VALUE ENGINEERING REPORT

East Hiram Parkway
Project No.: MSL-0004-00(688) Paulding County
PI No.: 0004688

December 12, 2007

SK-1

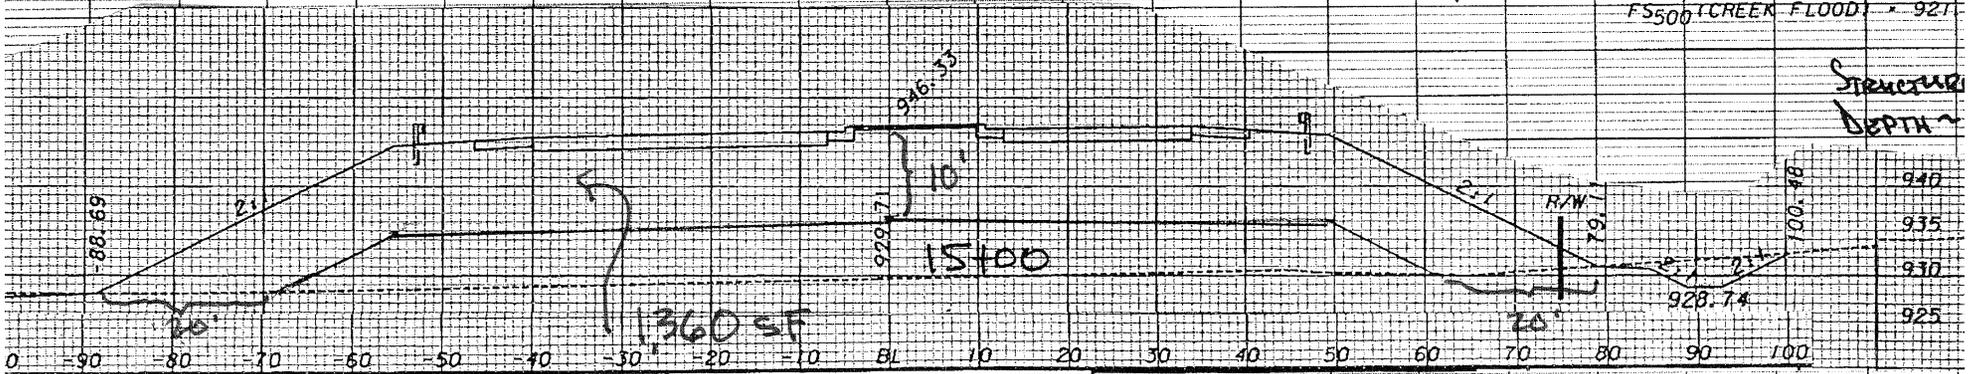
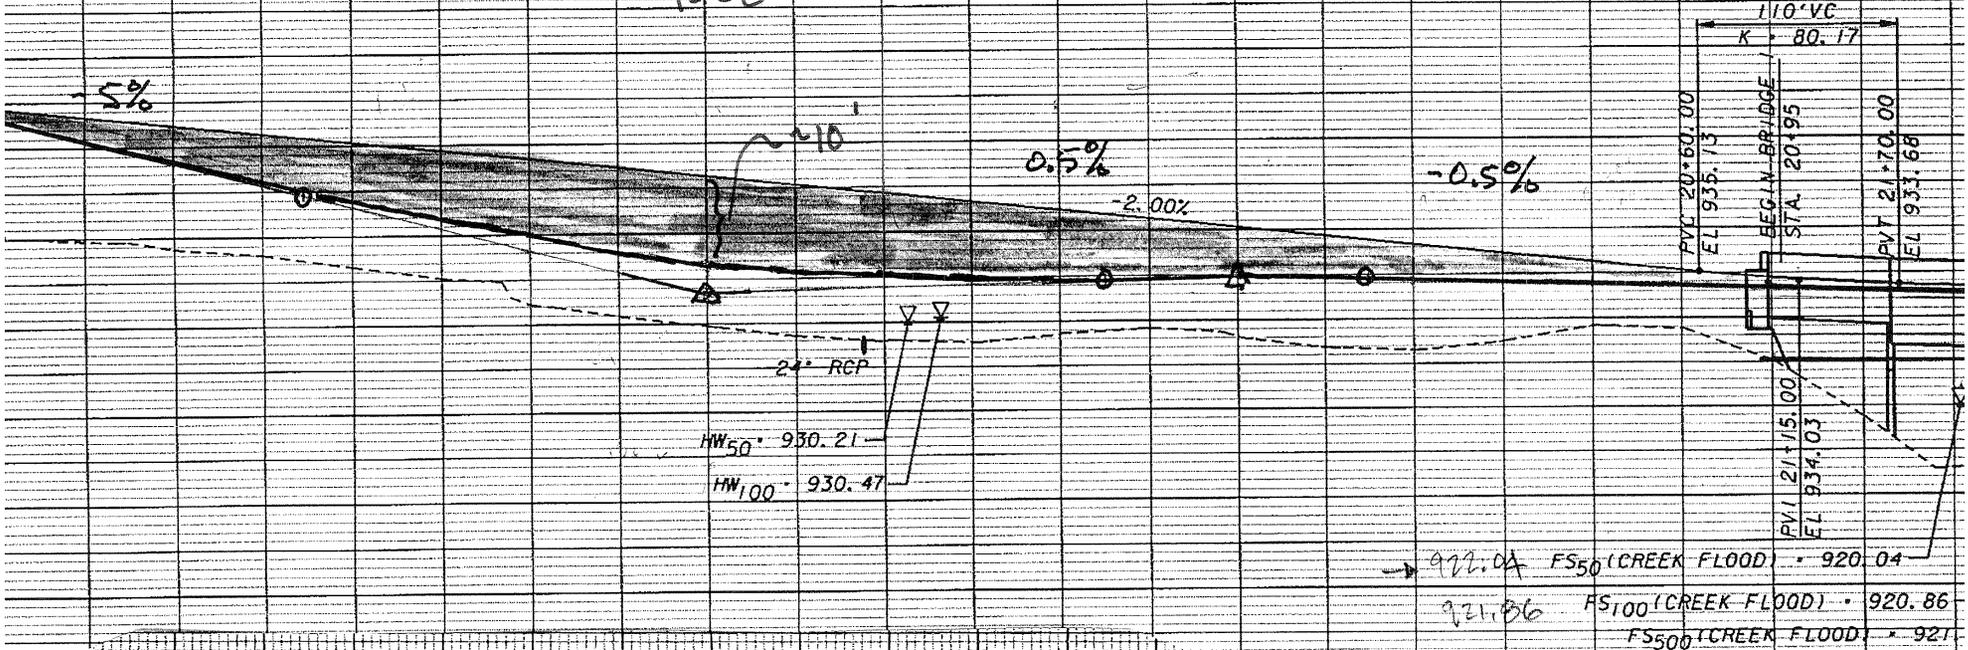
Profile modified as shown on attached sketches to reduce fill heights with some increase to cut areas west of the railroad.

Sta 11+00 to 21+00; Length = 1000 ft

Max reduction in fill ht = 10 ft

Max reduction in area = 1,360 sf (at cross section 15+00)

Earthwork volume reduced = $(1360 \times 1000/2)/27 = \mathbf{25,185 \text{ cy}}$

SK-2 A-4
Pg 3 of 7

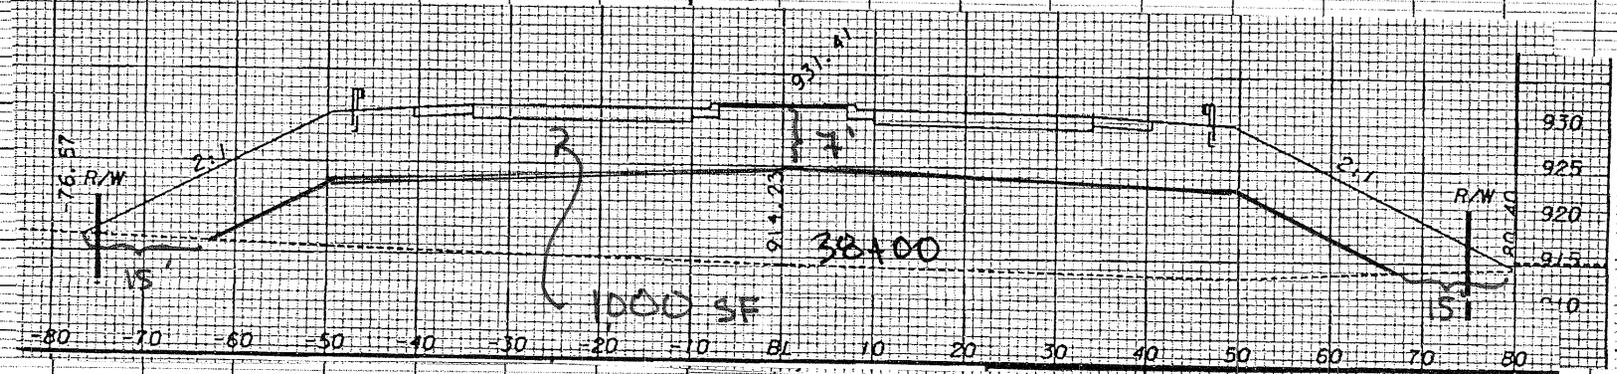
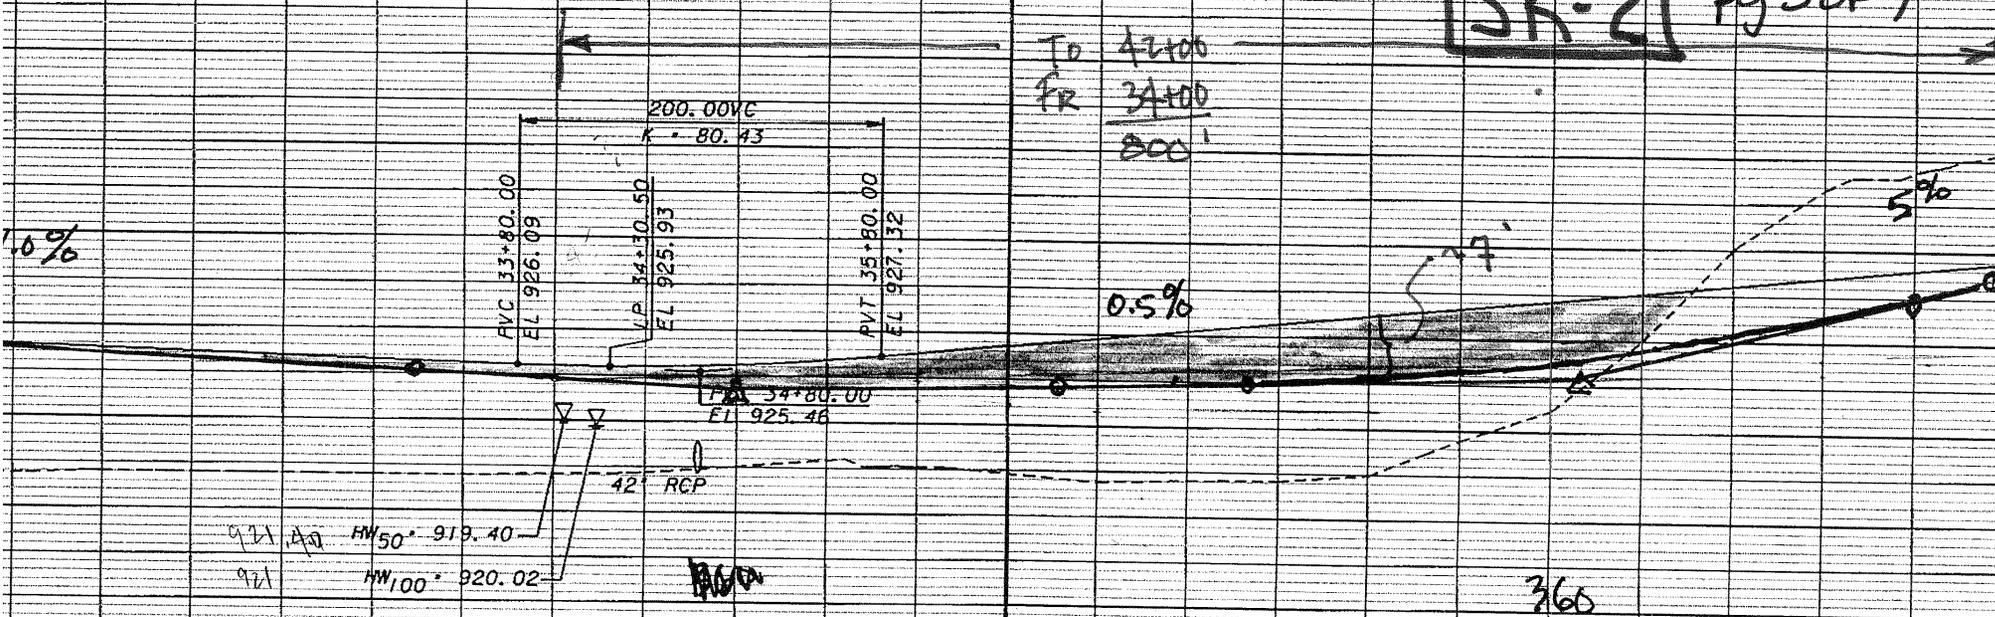
Sta 34+00 to 42+00; Length = 800 ft

Max reduction in fill ht = 7 ft

Max reduction in area = 1000 sf (at cross section 38+00)

Earthwork volume reduced = $(1000 \times 800/2)/27 = \mathbf{14,815 \text{ cy}}$

SK-4

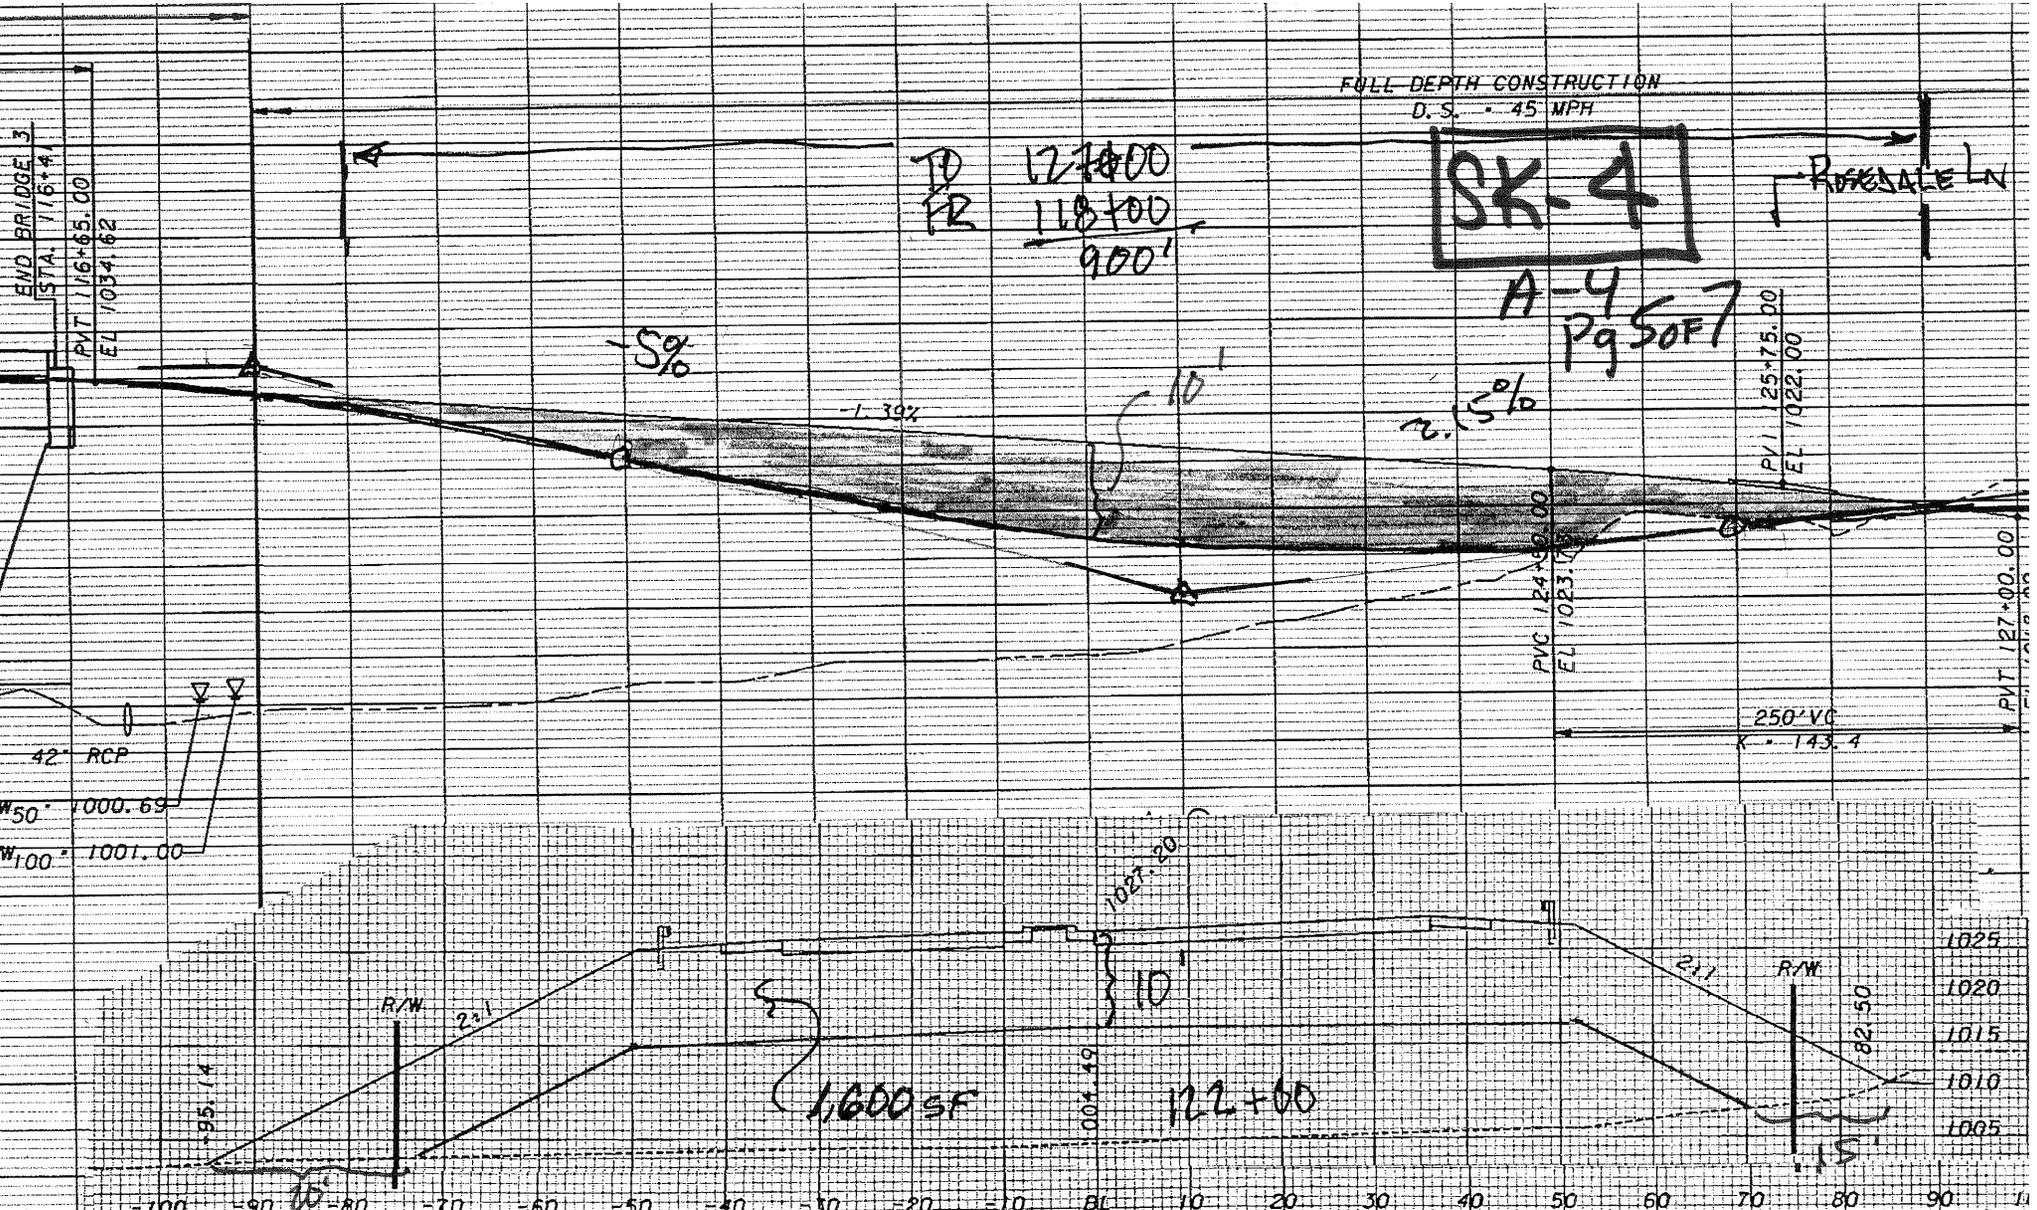
Sta 118+00 to 127+00; Length = 900 ft

Max reduction in fill ht = 10 ft

Max reduction in area = 1,600 sf (at cross section 122+00)

Earthwork volume reduced = $(1600 \times 900/2)/27 = \mathbf{26,665 \text{ cy}}$

ITEM N^o: B-1
CLIENT: GDOT
Sheet 2 of 5

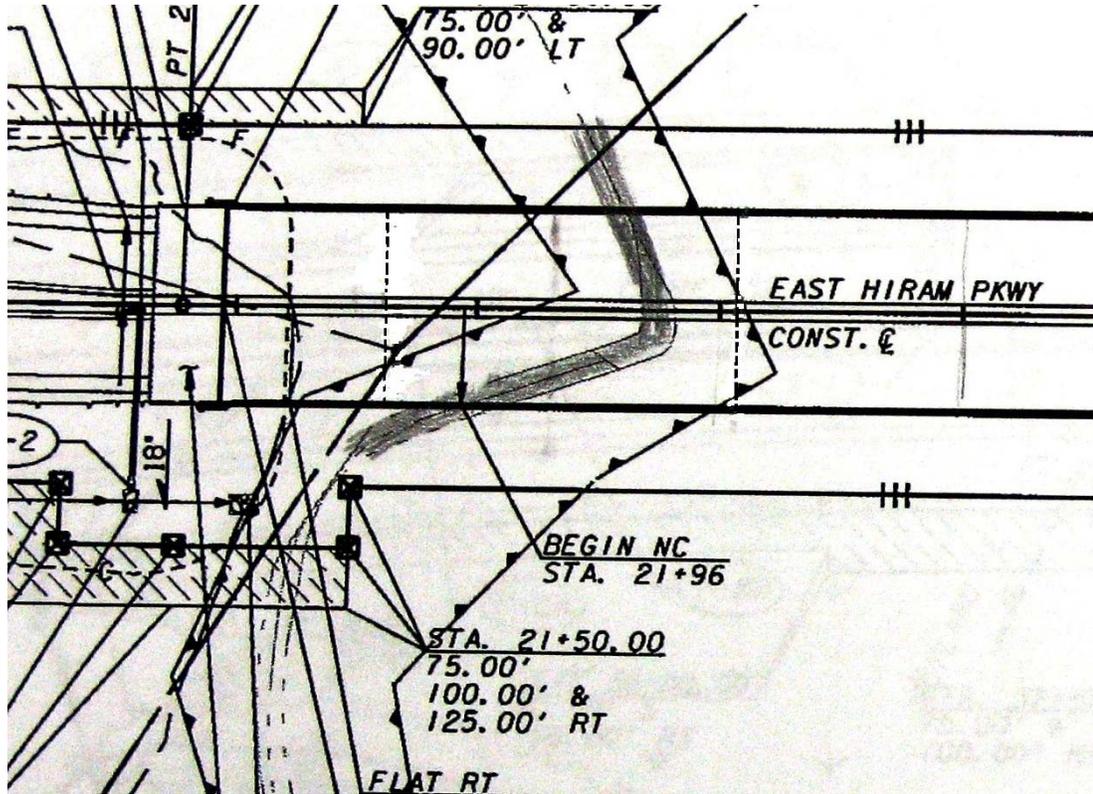
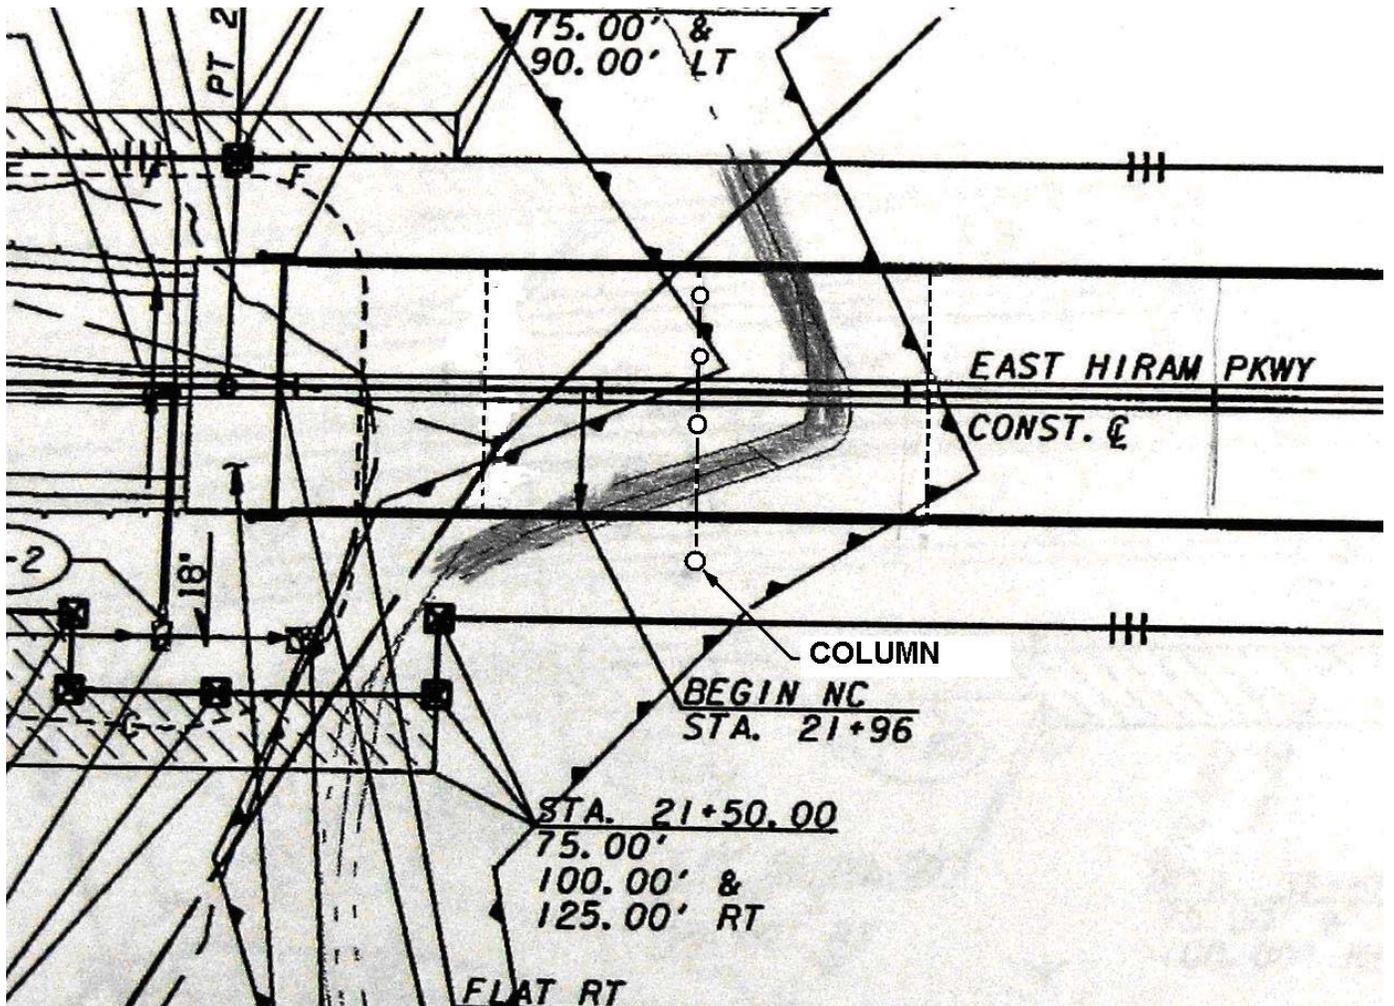
- Original Concept shown on Preliminary Layout has a 70 foot end span and a span 2 of 140 feet long. The remainder of the bridge is 40 foot RCDG (T-Beam) spans on pile bents.
- The length of Span 2 is determined by 10 foot setbacks of bents from the top of bank (per GDOT policy) for the meandering channel of Mill Creek as it passes under East Hiram Parkway.
- 72” deep bulb T beams are required for the 140 foot span.
- Because of this span length, bents 2 & 3 must be multi-column concrete intermediate bents.
- Rather than add an intermediate pile bent between bents 1 & 2 and use 2 spans of 40 foot RCDG beams, the designer chose to utilize the intermediate concrete bent and have an end span of 70 feet.

Replace span 2 with (2) – 70 foot spans and add a concrete intermediate bent between the original concept bents 2 & 3. This bent will have concrete columns placed so as to maintain the 10 foot offset from the top of banks and be perpendicular to the centerline of the roadway. Structure depth will be 3’-9” for the AASHTO Type III span.

Allows for lowering the profile grade to save cost of grading, earthwork and ROW

ITEM N^o: B-4
CLIENT: GDOT
Sheet 2 of 4

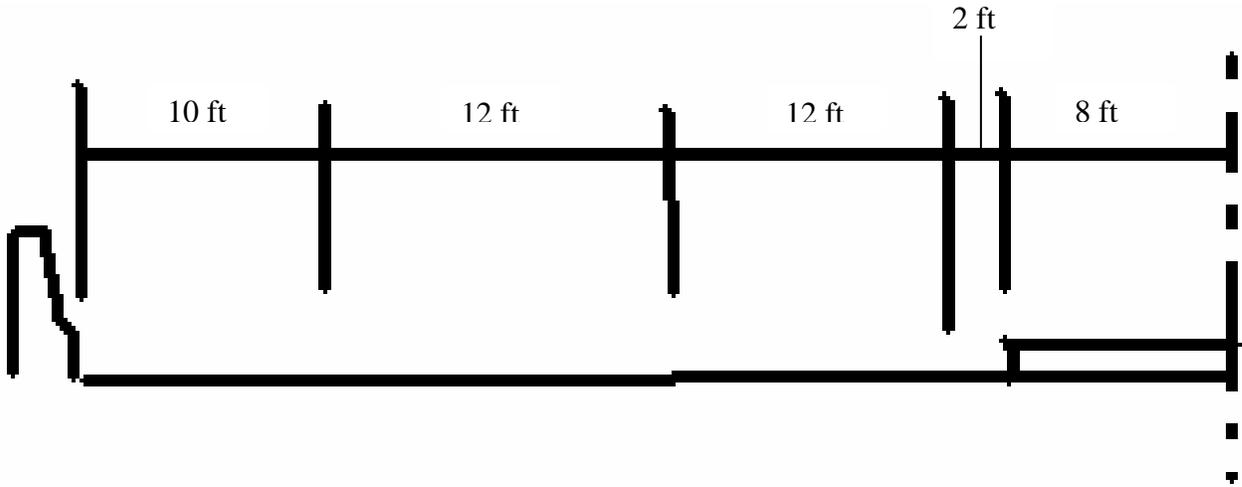
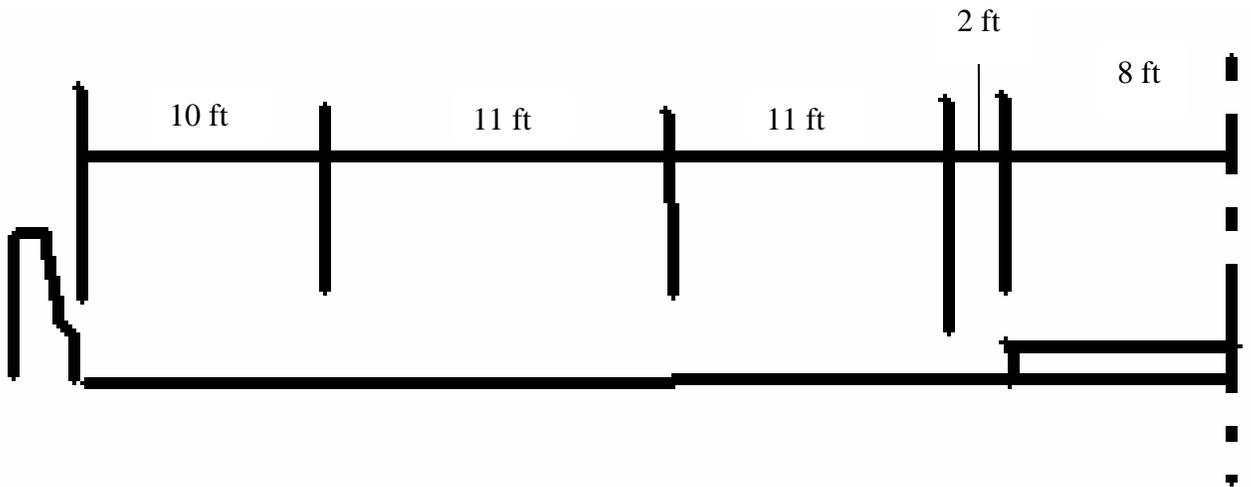
Original concept uses 4 – 12 foot lanes.

Reduce lanes to 11 foot wide.

Roadway is 45 mph design speed. Reducing lane width is deemed acceptable by current design practice and will not require a design variance.
